# ADDENDUM NO. 1

**April 29, 2022**

**NEW ADMINISTRATION CENTER, ALTERNATE EDUCATION AND  
RESOURCE CENTER AND RELATED WORK PROJECT  
Crown Point, IN 46307**

This Addendum forms a part of and modifies the Bidding Requirements, Contract Forms, Contract Conditions, the Specifications, and the Drawings dated April 15, 2022 by Gibraltar Design. Acknowledge receipt of the Addendum in the space provided on the Bid Form. Failure to do so may subject the Bidder to disqualification.

1. 12"ø x 4" FRAME AND COVER SHALL BE EAST JORDAN V1610-2BF RG V1610-2CV ASSEMBLY, OR APPROVED EQUAL.
2. 24"ø x 4" FRAME AND COVER SHALL BE V1600-3 V1610-3 ASSEMBLY, OR APPROVED EQUAL.

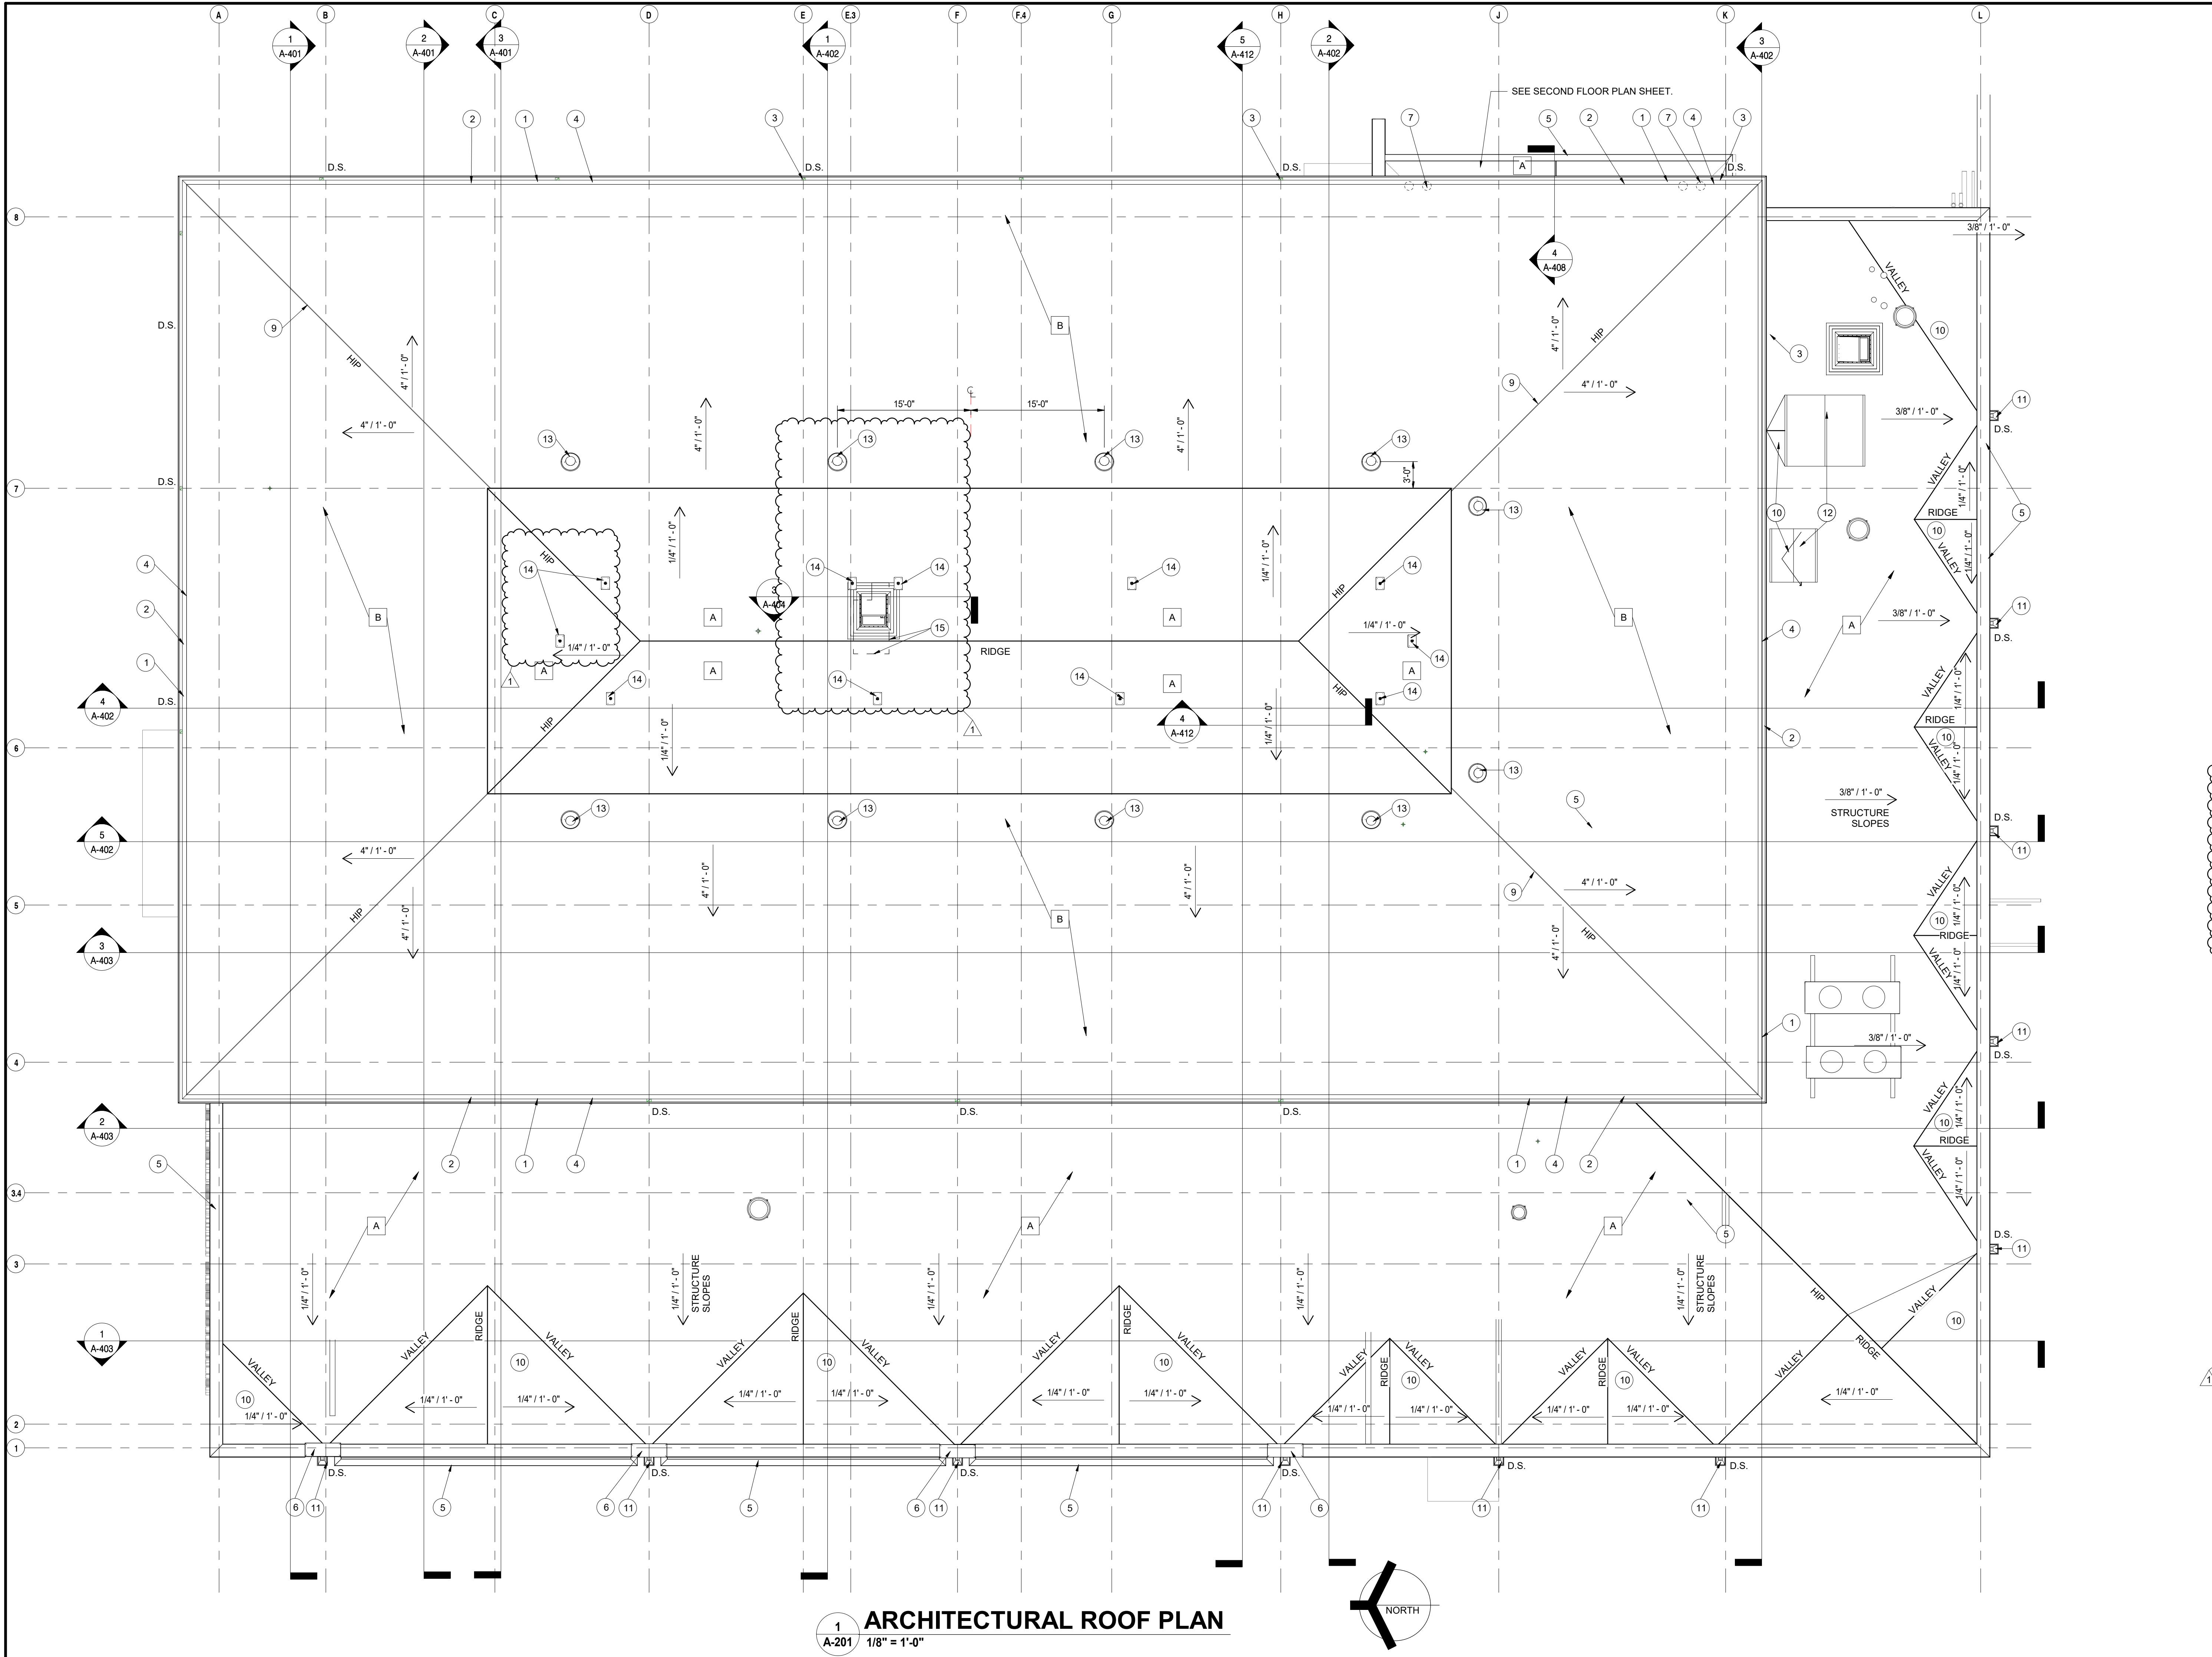
**5. Sheet C-115**

- A. Refer to revised, full size drawing, included in this Addendum, for the following revisions:
1. Add "CDS3035-6-C-707498-10 Hydrodynamic Separator" detail.
  2. Add "Frame and Cover Notes" section regarding the hydrodynamic separator structure castings to be used.

1. "CDS3035-6-C-707498-10" HYDRODYNAMIC SEPARATOR STRUCTURE DETAIL HAS BEEN ADDED.
2. "FRAME AND COVER NOTES" REGARDING THE HYDRODYNAMIC SEPARATOR STRUCTURE CASTINGS HAVE BEEN ADDED.

**FIRST FLOOR EQUIPMENT PLAN**  
1 A-701 1/8" = 1'-0"

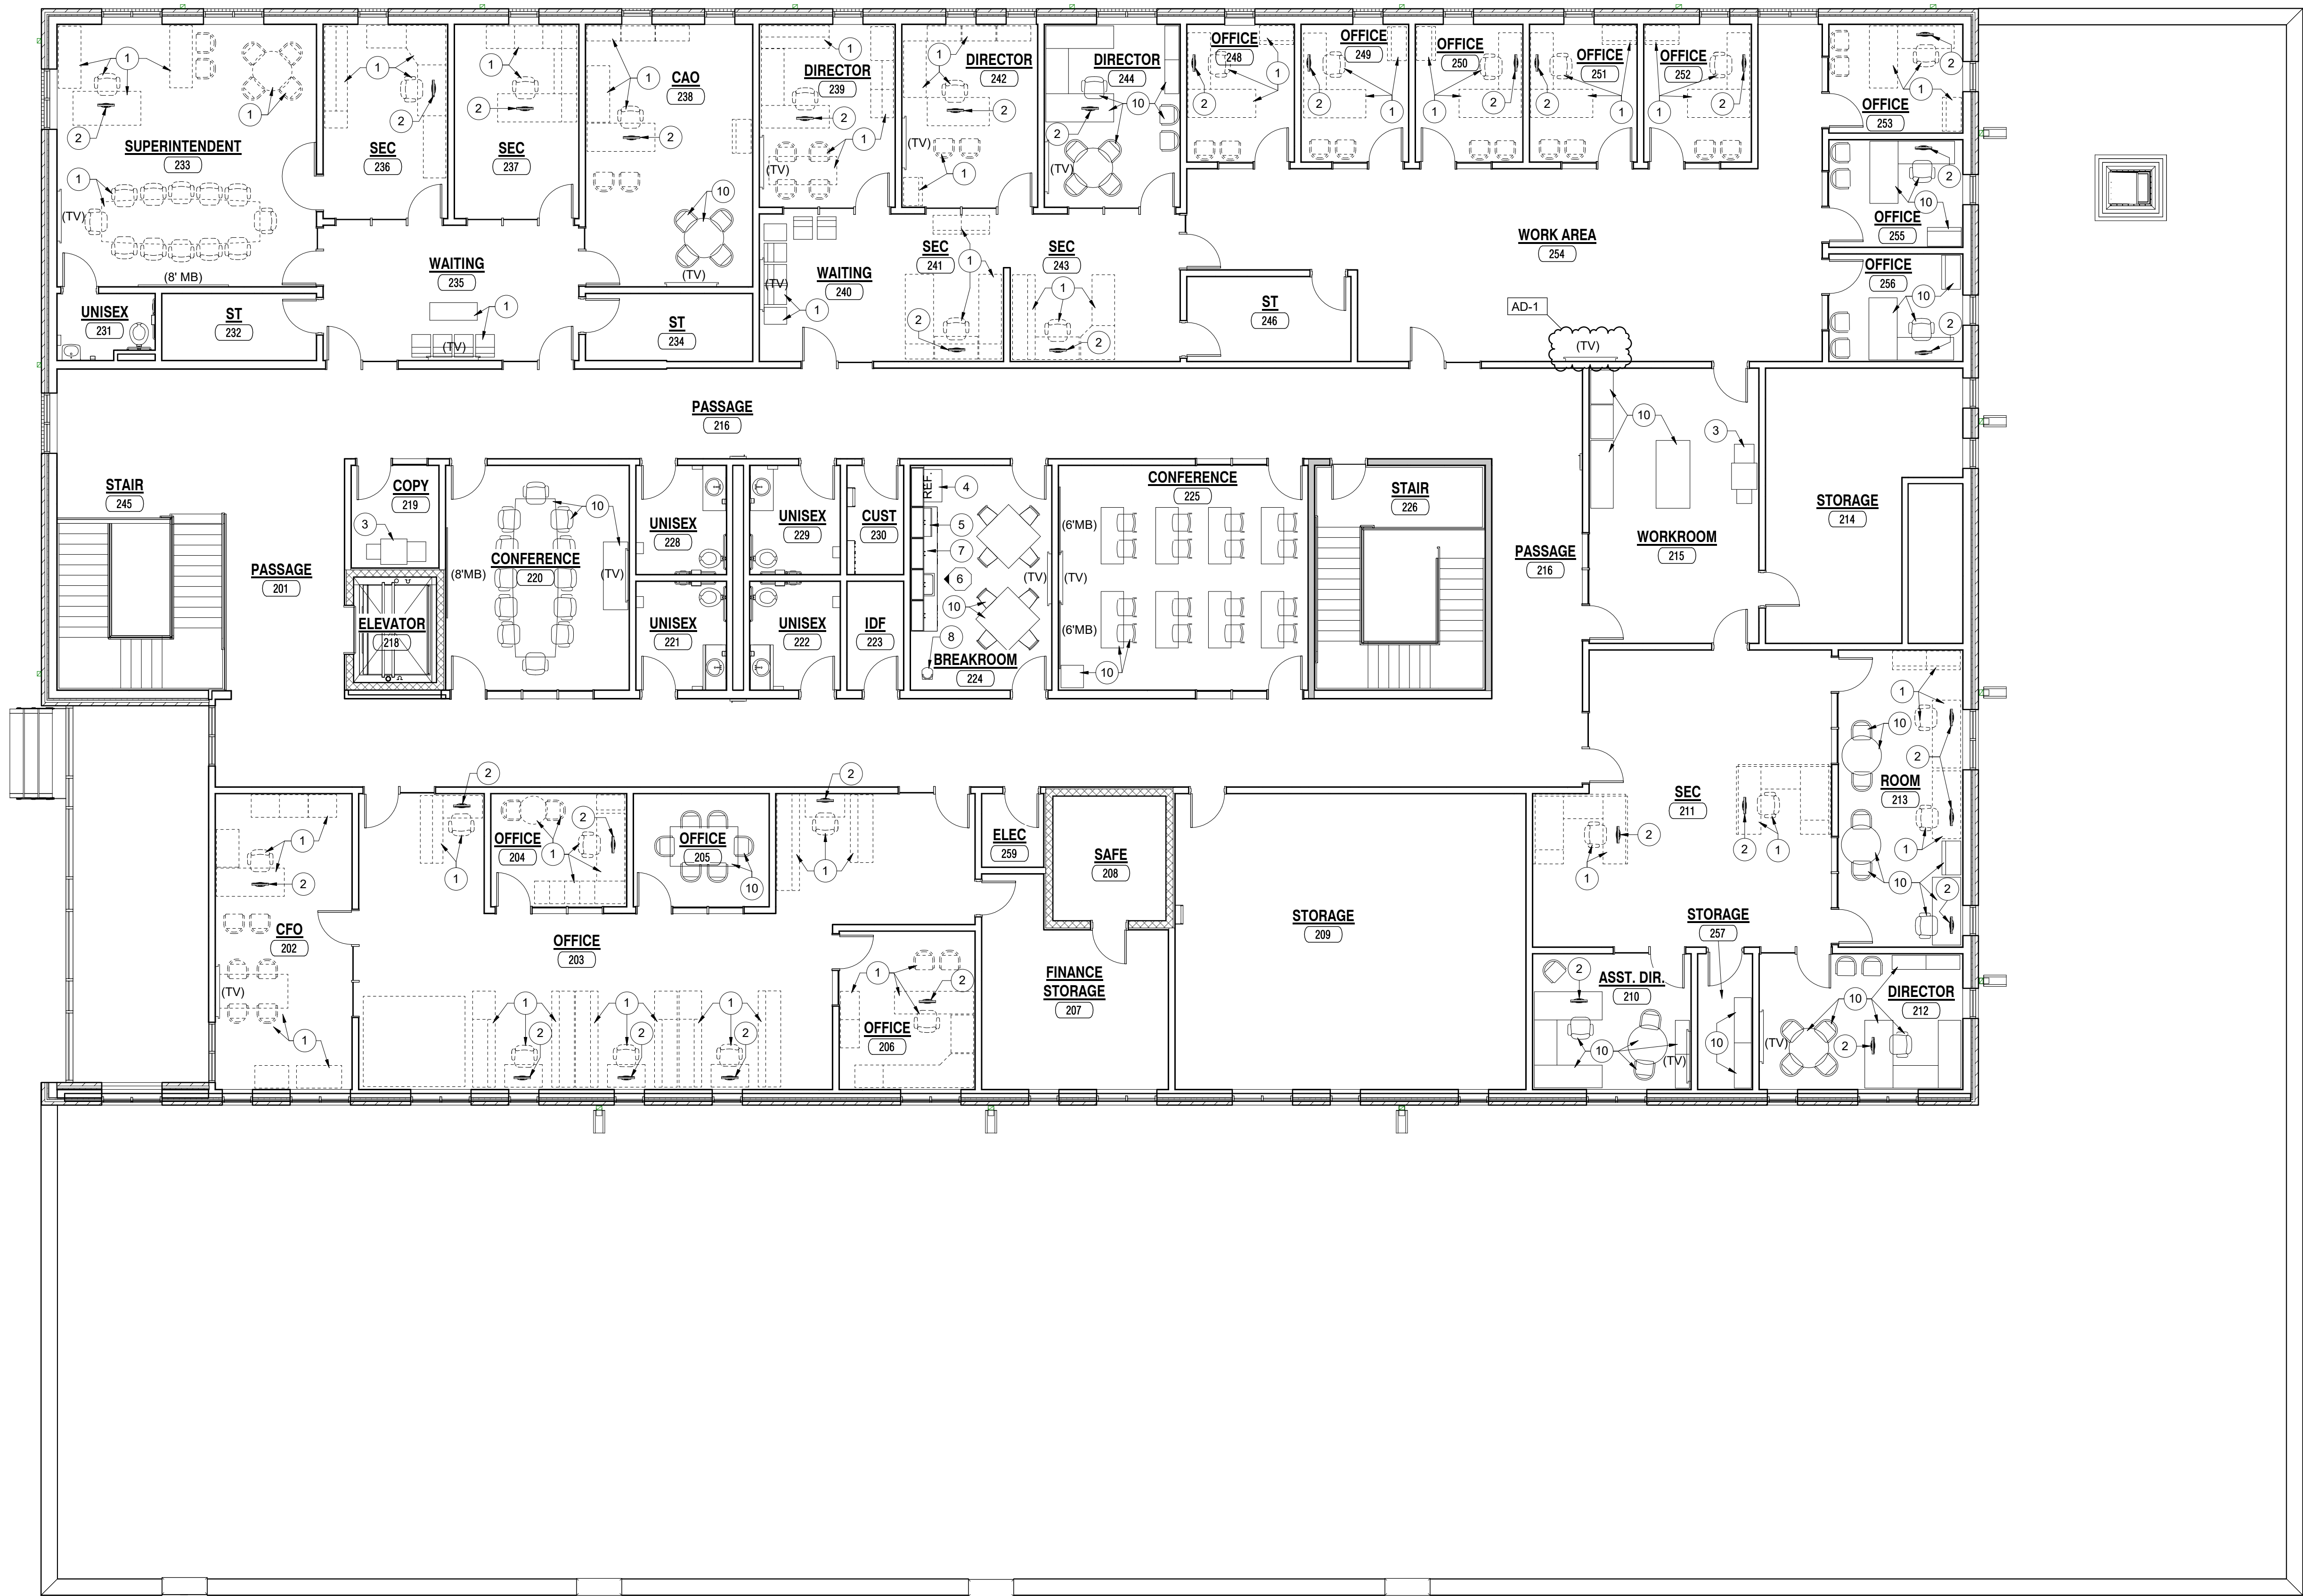
REMOVE ROLLER SHADES (RS) AT ALL LOCATIONS.
